Union of Concerned Scientists

SUBJECT: FIRSTENERGY'S DAVIS-BESSE REPORT

I read your letter dated February 23, 2007, to Mr. Gary R. Leidich at FirstEnergy Nuclear Operating Company (FENOC) regarding the report prepared by Exponent Failure Analysis Associates and Altran Solutions Corporation about reactor vessel head degradation at the Davis-Besse nuclear plant. FENOC submitted the report to the Nuclear Regulatory Commission (NRC), which is available in the NRC's ADAMS online electronic library under ML070860211. I have read the report, too.

Figure 7.2 Three-day average unidentified leak rate for Davis-Besse Cycle 13¹⁷

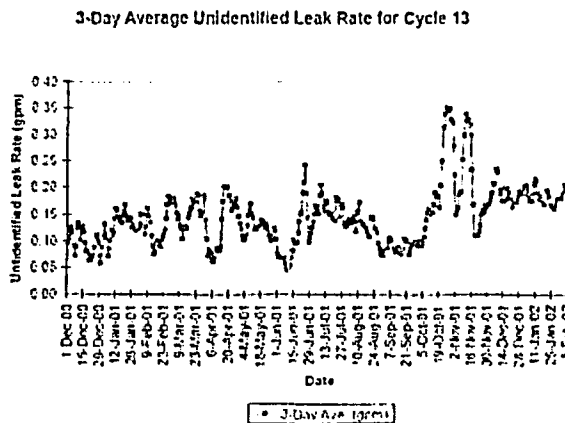
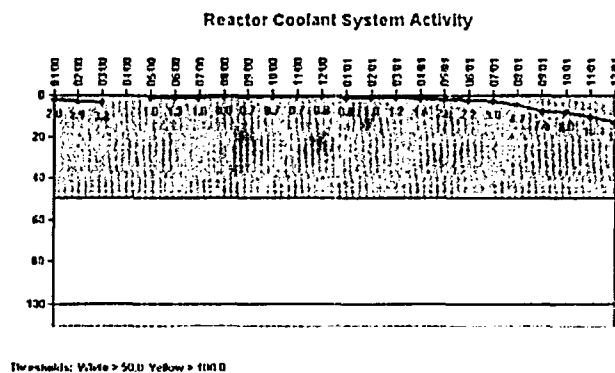
- The Exponent / Altran report relies on circumstantial evidence to support the theory of crack uncovering in the October – November 2001 timeframe. Among the cited evidence is an increase in unidentified leak rate occurring after October 19, 2001. Figure 7.2 from the Exponent / Altran report shows this increase. But the report does not mention or account for the fact that Davis-Besse was shut down on October 19, 2001, and restarted less than a day later due to a generator stator cooling water problem. The thermal cycling associated with shutting down and restarting a nuclear power plant could easily explain a discernible yet minor increase in the unidentified leakage rate.
